STAFF REPORT: APRIL 13, 2022 MEETING

APPLICATION NUMBER: 22-7706

ADDRESS: 19388 STRATFORD

SCOPE: REPLACEMENT OF VINYL WINDOWS WITH FIBREX WINDOWS AT THE FIRST FLOOR

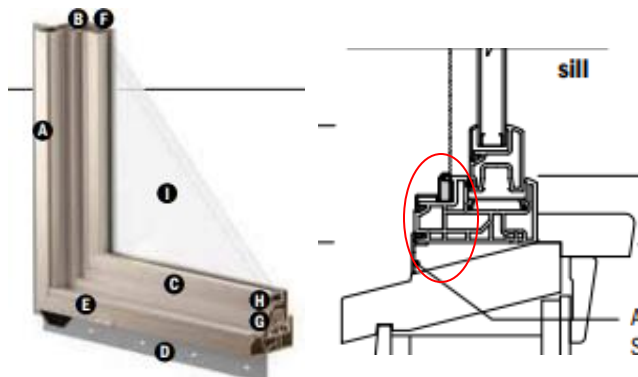
<u>Vertical stile</u>	1-1/2”	1-1/4”	1/4” increase approx.
<u>Meeting rail</u>	2-1/4”	1-11/16”	1/2” increase approx.
<u>Bottom rail</u>	3-1/8”	3-3/4”	5/8” decrease

The 3-1/8” dimension is broken down into a bottom rail and stepped back frame, which is different than the wood-clad window.

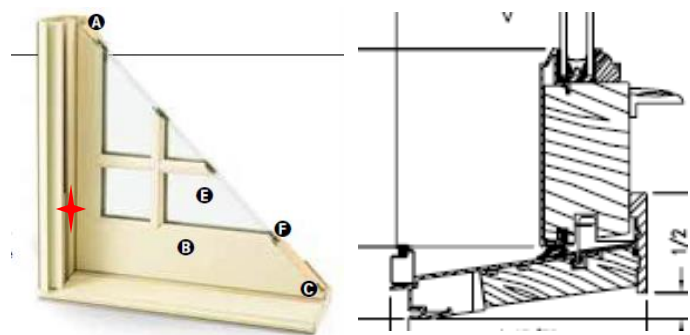
100 Series, Fibrex single-hung unit
This unit has an approximately 2” bottom rail, however it is partially covered up on the exterior by additional window framing.

Wood, aluminum-clad double-hung unit
This unit retains a traditional proportion of a historic wood window bottom rail, but has a visible and mis-matched jamb liner within the lower frame (due to the operable upper sash).

APPLICANT PHOTOS –WINDOW OPENINGS WITHIN APPLICATION

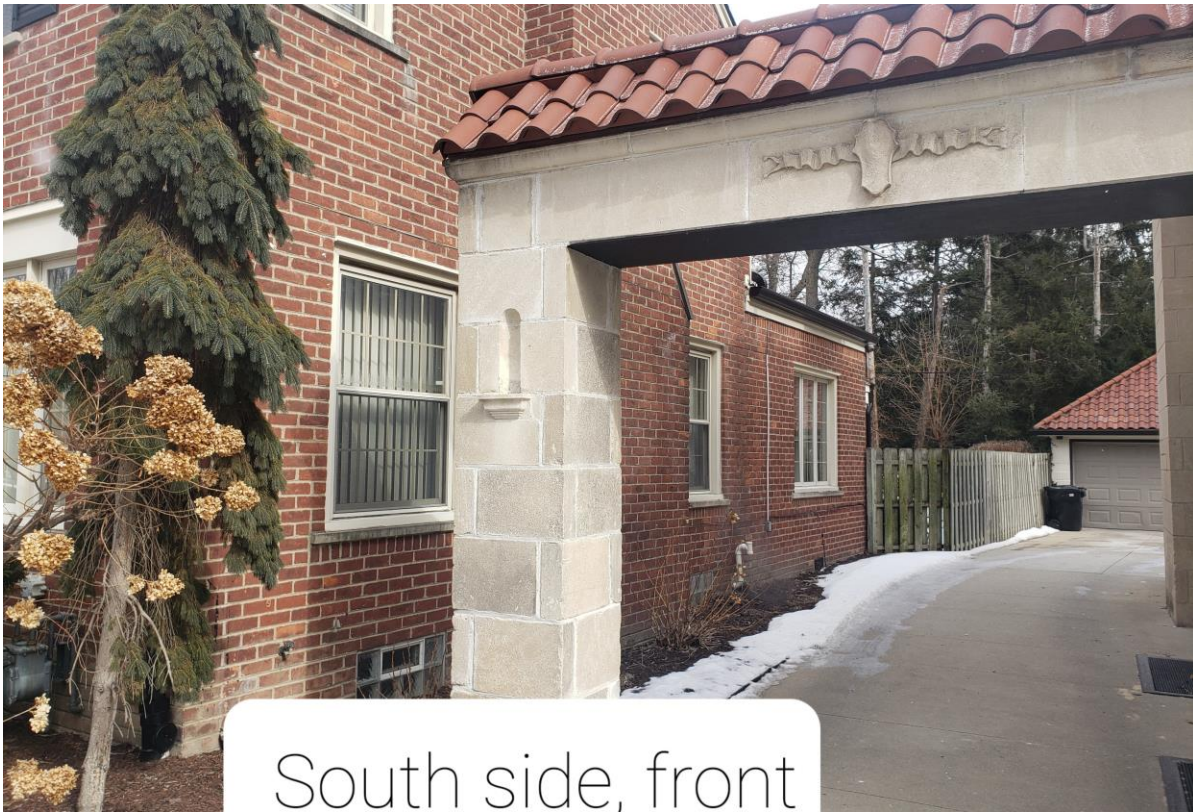
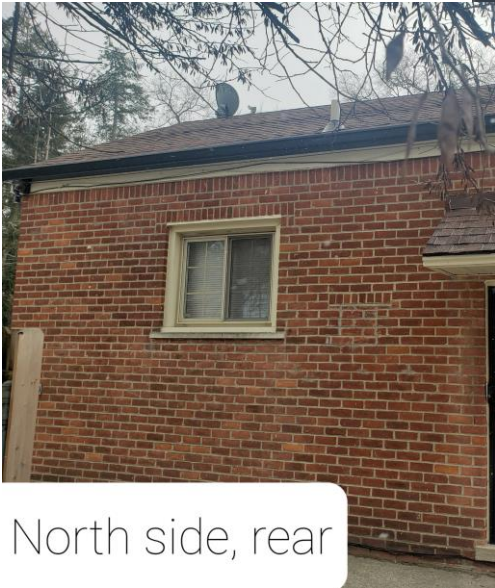
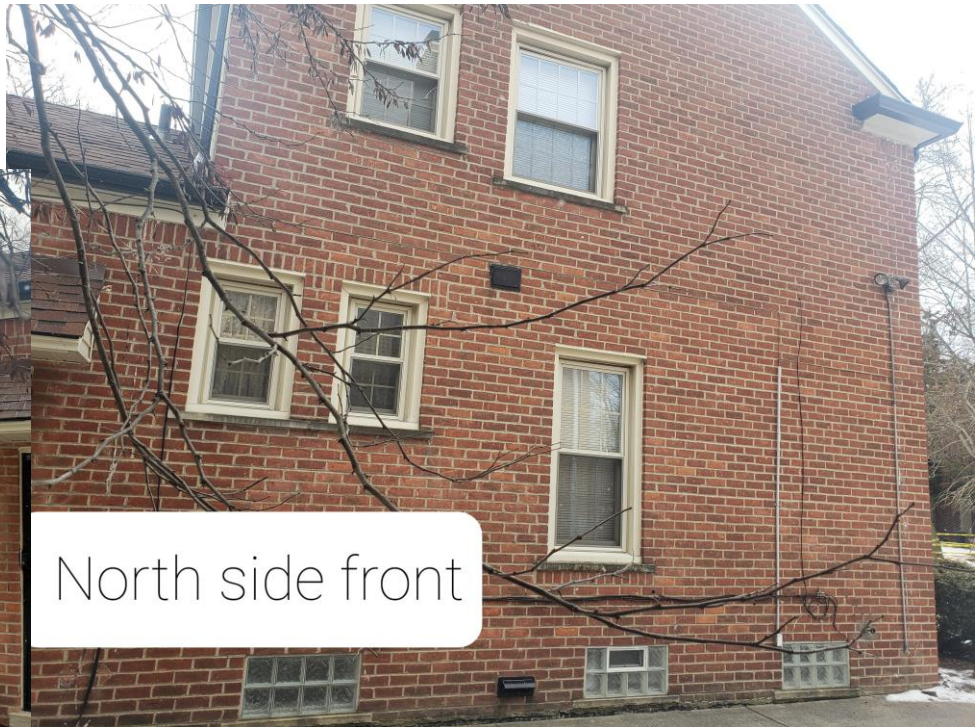
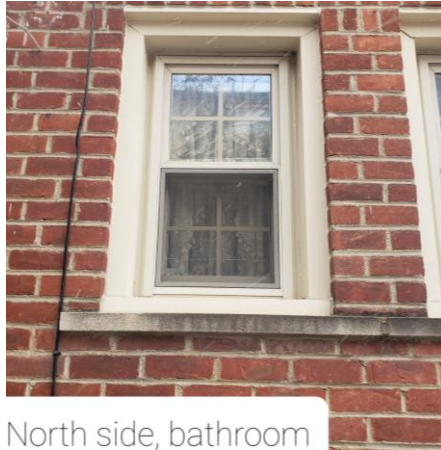
- Staff requested additional information related to the scope of work. The applicant replied to only a few questions, as shown below.
 - I noticed that only one bathroom window is proposed for replacement, is that correct? (photos page 9)

- One office window is mentioned for replacement but a single window picture identifying the office window wasn't submitted. Is it the windows to the left of the front door at the front of house, or is it the opening on the north side of the house nearest the front elevation? (elevation photos pages 7 & 9)

- Photos of two window openings on the rear elevation were submitted (page 7), but a full elevation photo of the rear elevation was not submitted. Please submit a full rear elevation picture so that we have a full understanding of the locations of the windows to be replaced.
